UNITED STATES
NUCLEAR REGULATORY COMMISSION
WASHINGTON, D.C. 20555-0001

SUBJECT: CLINTON POWER STATION, UNIT NO.1 - STAFF ASSESSMENT OF INFORMATION PROVIDED PURSUANT TO TITLE 10 OF THE *CODE OF FEDERAL REGULATIONS* PART 50, SECTION 50.54(f), SEISMIC HAZARD REEVALUATIONS FOR RECOMMENDATION 2.1 OF THE NEAR-TERM TASK FORCE REVIEW OF INSIGHTS FROM THE FUKUSHIMA DAI-ICHI ACCIDENT (TAC NO. MF3783)

STAFF ASSESSMENT BY THE OFFICE OF NUCLEAR REACTOR REGULATION

CLINTON POWER STATION, UNIT NO.1

Figure 3.3-1 Plot of the Staff's and Licensee's Base Case Shear-Wave Velocity Profiles for the Clinton Site

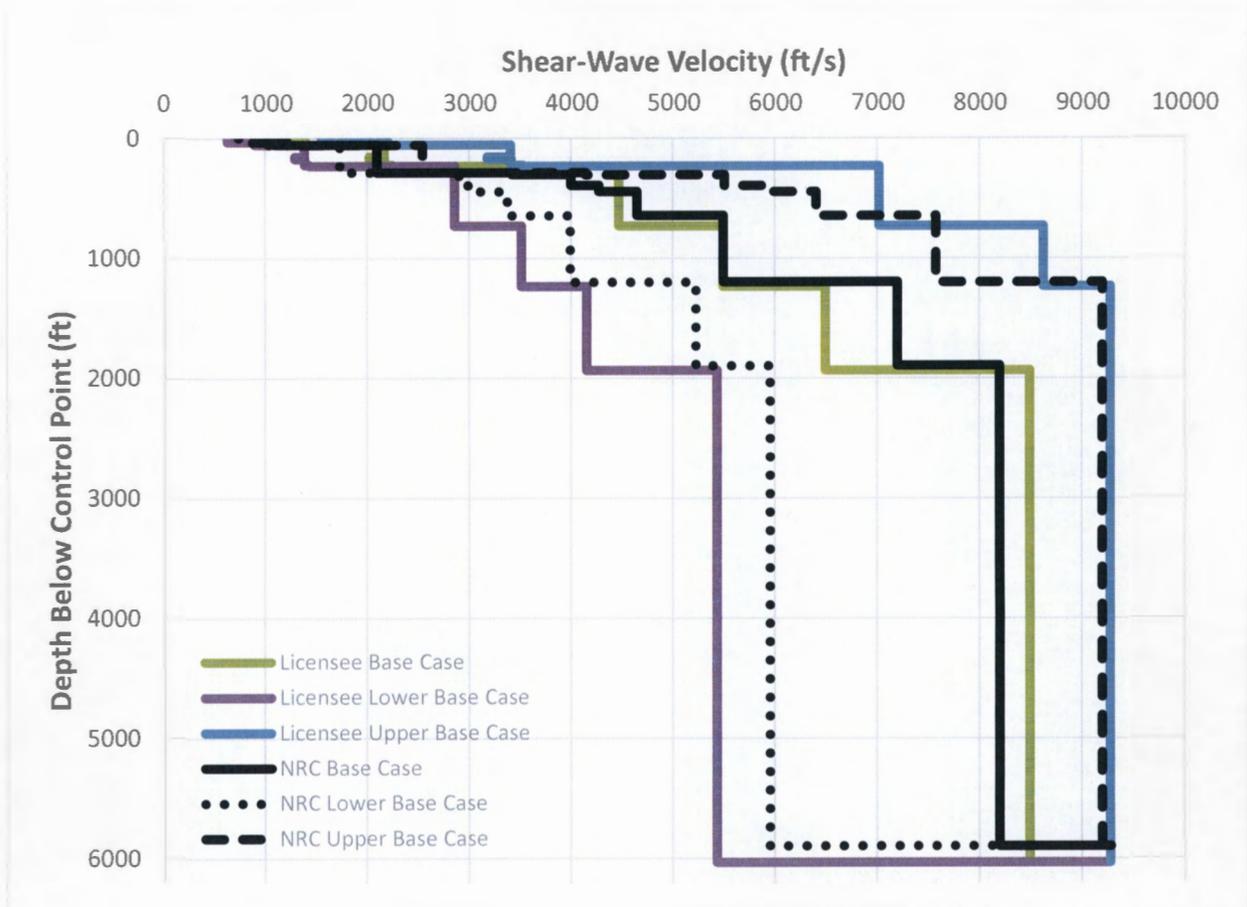
The licensee developed three base case shear-wave velocity profiles for the Clinton site. Using the shear-wave velocities determined from refraction, uphole and downhole surveys, as well as nearby measurements for recent Early Site Permit (ESP) investigations, the licensee calculated the mean base-case profile. The licensee calculated the lower and upper base case shear-wave velocity profiles using a scale factor of 1.57 reflecting a natural log standard deviation of 0.35. Table 2.3.2-1 and Figure 2.3.2-1 of the SHSR provide the licensee's shear-wave velocity profile for each of the three base cases. Figure 3.3-1 of this assessment shows the licensee's three shear-wave velocity base case profiles.

developed input ground motions in accordance with Appendix B of the SPID. Following guidance provided in the SPID for sites with less subsurface information, the NRC staff independently determined best-estimate and upper and lower base case shear-wave velocity profiles. The NRC staff based its best-estimate velocity profile on information provided in the SSAR for the Clinton ESP site. Data collected as part of the Clinton ESP licensing is consistent with data collected when siting the currently operating plant. However, the newer data extends to greater depth and was collected using more modern methods.

The NRC staff modeled the upper 290 ft. (89 m) as layered glacial and lake deposits with shear-wave velocities of 900 to 2,100 fps (274 – 640 m/s). The upper 18 ft. (5.5 m) of rock was modeled as highly weathered with a best-estimate velocity of 3,420 fps (1,042 m/s) to account for the unconformity (gap in geologic ages) between the top of rock and the soil layers above. Below this, to a depth of 1,900 ft. (579 m), the NRC staff modeled the subsurface as rock with a generally increasing velocity as a function of depth. The NRC staff assumed a best-estimate velocity of 4,000 fps (1,219 m/s) for the uppermost rock layers. Between depths of 1900 ft. (m) and a depth of 5,900 ft. (1,798 m), where base rock is assumed to be located, the NRC staff used a constant best-estimate velocity of 8,200 fps (2,499 m/s) and assumed a natural log standard deviation of 0.15 in the soil and weathered rock layers and 0.25 in the rock layers to calculate upper and lower base case profiles. Figure 3.3-1 of this assessment shows a comparison of the three velocity profiles developed by the licensee with those developed by the NRC staff. The profiles developed by the licensee are similar in shape to those developed by the NRC staff. However, the licensee's show greater variability, particularly in the soil portion of the profiles due to the licensee's use of a higher natural log standard deviation. The NRC staff randomized the depth to reference rock by ± 10 percent to allow for additional uncertainty.

Figure 3.3- 2 Plot Comparing the Staff's and the License's Median Amplification Functions and Uncertainties for two input loading levels for the Clinton Site

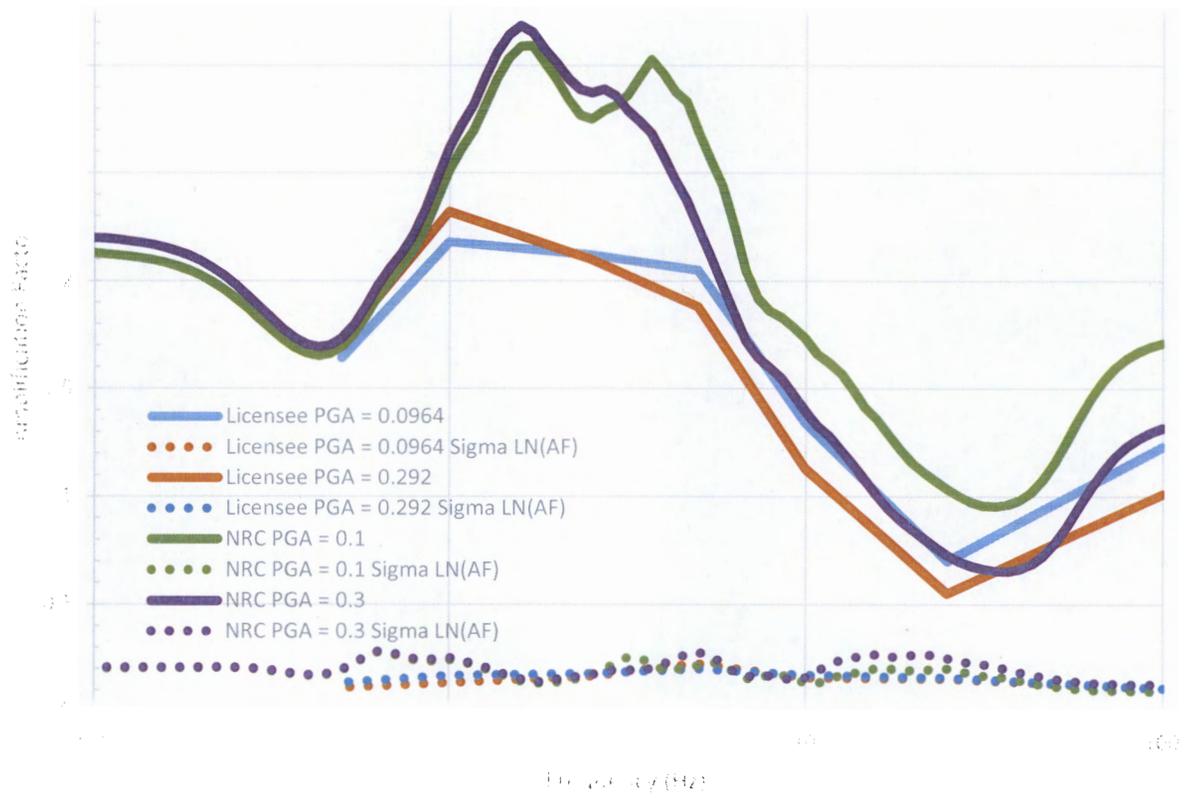
Figure 3.3-2 of this assessment shows a comparison of the staff's and the licensee's median site amplification functions and uncertainties (± 1 standard deviation) for two of the eleven input loading levels. Peaks in amplification functions occur at approximately 1.5 and 4 Hz in both the staff's and the licensee's curves. Differences in site amplification curves developed by the NRC staff and the licensee are due to differences in site velocity profiles and the licensee's use of

damping over the upper 500 ft. (152 m) of the profile, rather than the 308 ft. (94 m) used by the NRC staff.

Figure 3.3-3 Plot Comparing the Staff's and the Licensee's Mean Control Point Hazard Curves at a Variety of Frequencies for the Clinton Site

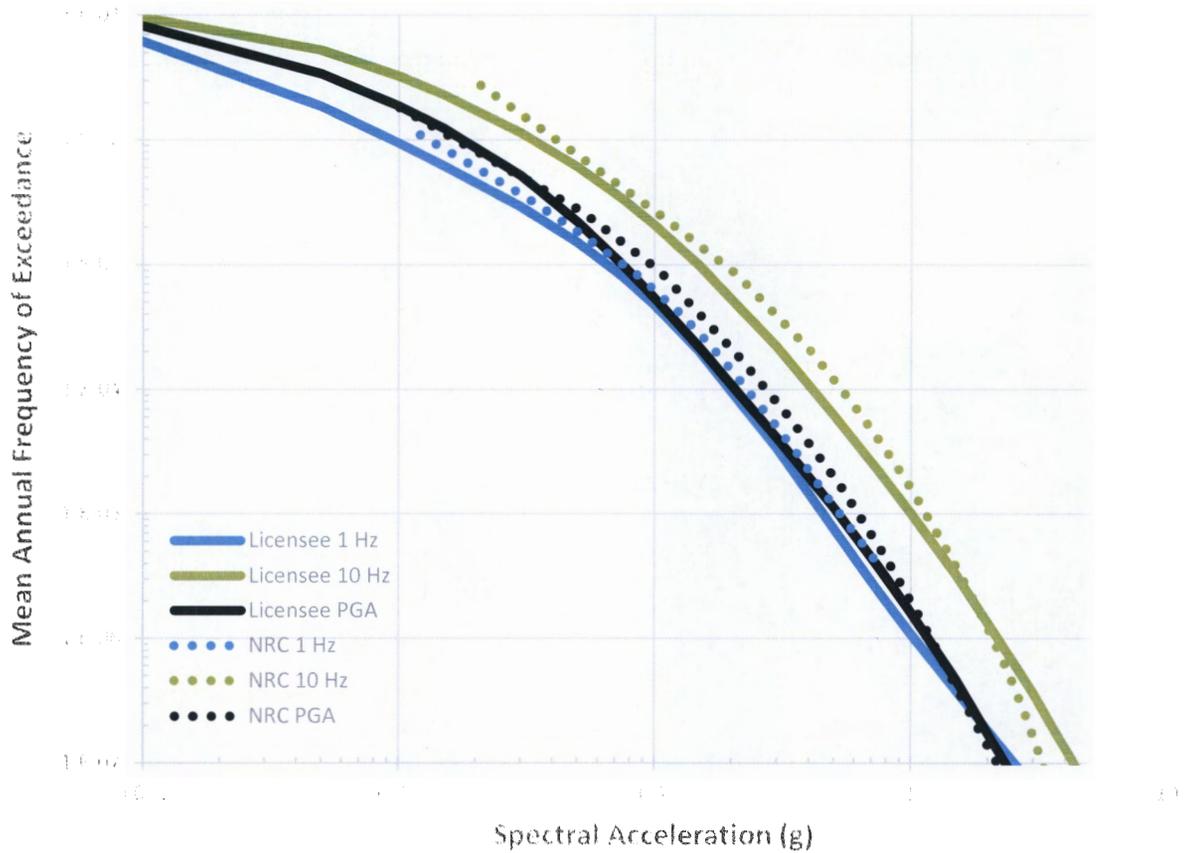
The licensee's approach to modeling the subsurface soil and rock properties and their uncertainties results in lower site amplification factors than those produced by the NRC staff, particularly at high frequencies. As shown in Figure 3.3-3 of this assessment, these differences in site response have a moderate impact on control point seismic hazard curves and the resulting GMRS, discussed below. Appendix B of the SPID provides guidance for performing site response analyses, including capturing the uncertainty for sites with less subsurface data; however, the guidance is neither entirely prescriptive nor comprehensive. As such, various approaches in performing site response analyses, including the modeling of uncertainty, are acceptable for the 50.54(f) response.

In summary, the NRC staff concludes that the licensee's site response was conducted using present-day guidance and methodology, including the NRC-endorsed SPID. The NRC staff performed independent calculations which confirmed that the licensee's amplification factors and control point hazard curves adequately characterize the site response, including the uncertainty associated with the subsurface material properties, for the Clinton site.

Figure 3.4-1 Comparison of the Staff's GMRS, Licensee's GMRS, and Clinton Site SSE.

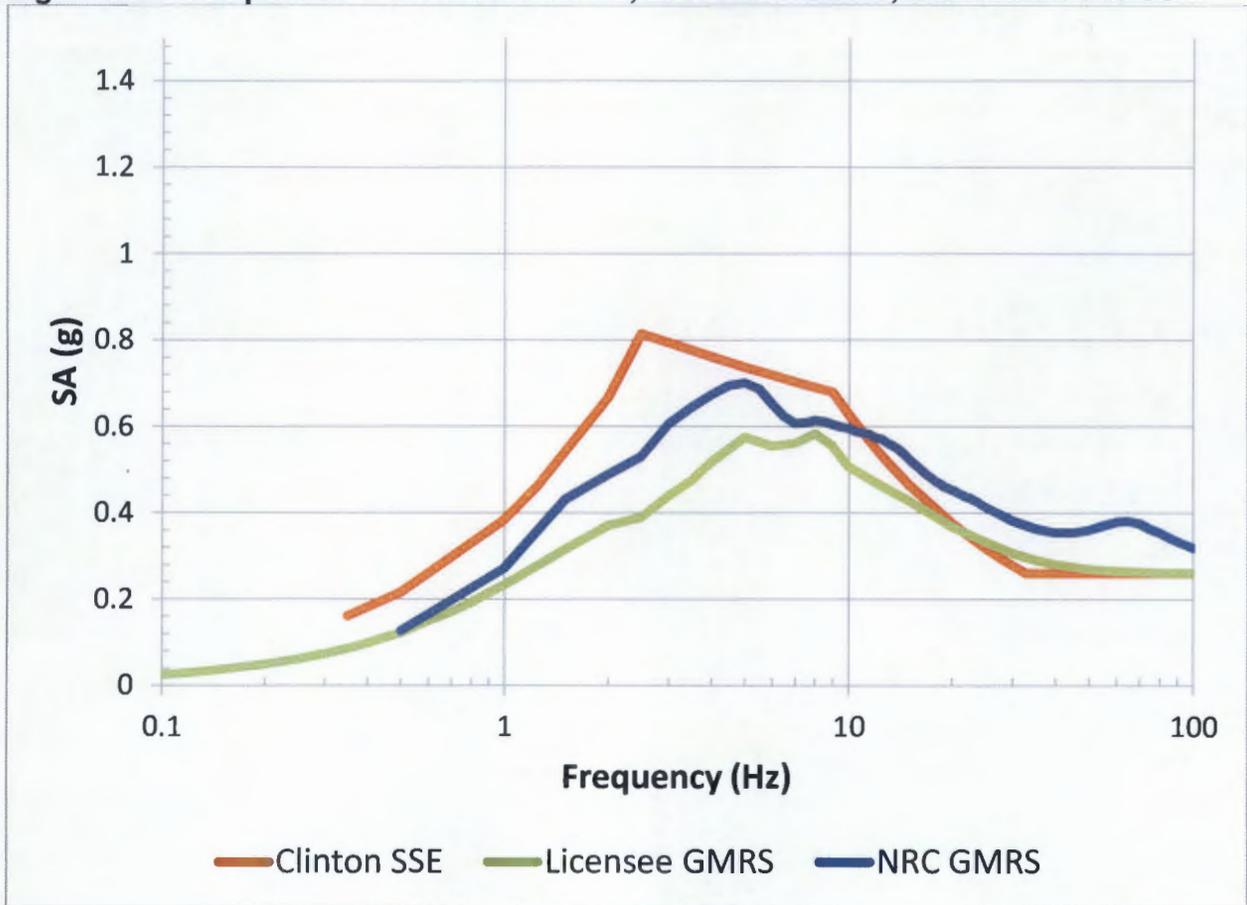
The NRC staff independently calculated the 10^{-4} and 10^{-5} UHRS using the results of its confirmatory PSHA and site response analyses, as described in Sections 3.2 and 3.3 of this staff assessment, respectively. Figure 3.4-1 of this assessment shows a comparison of the GMRS determined by the licensee to that determined by the NRC staff.

As shown in Figure 3.4-1, the licensee's GMRS shape is generally similar to that calculated by the NRC staff across all frequencies. However, NRC staff's confirmatory GMRS envelopes the licensee's. As described above in Section 3.3, the NRC staff concludes that these differences are primarily due to the differences in the site response analyses performed by the licensee and NRC staff.

The NRC staff confirms that the licensee used the present-day guidance and methodology outlined in RG 1.208 and the SPID to calculate the horizontal GMRS, as requested in the 50.54(f) letter. The NRC staff performed both a PSHA and site response confirmatory analysis and achieved results consistent with the licensee's horizontal GMRS. As such, the NRC staff concludes that the GMRS determined by the licensee adequately characterizes the reevaluated hazard for the Clinton site. Therefore, this GMRS is suitable for use in subsequent evaluations and confirmations, as needed, for the response to the 50.54(f) letter.
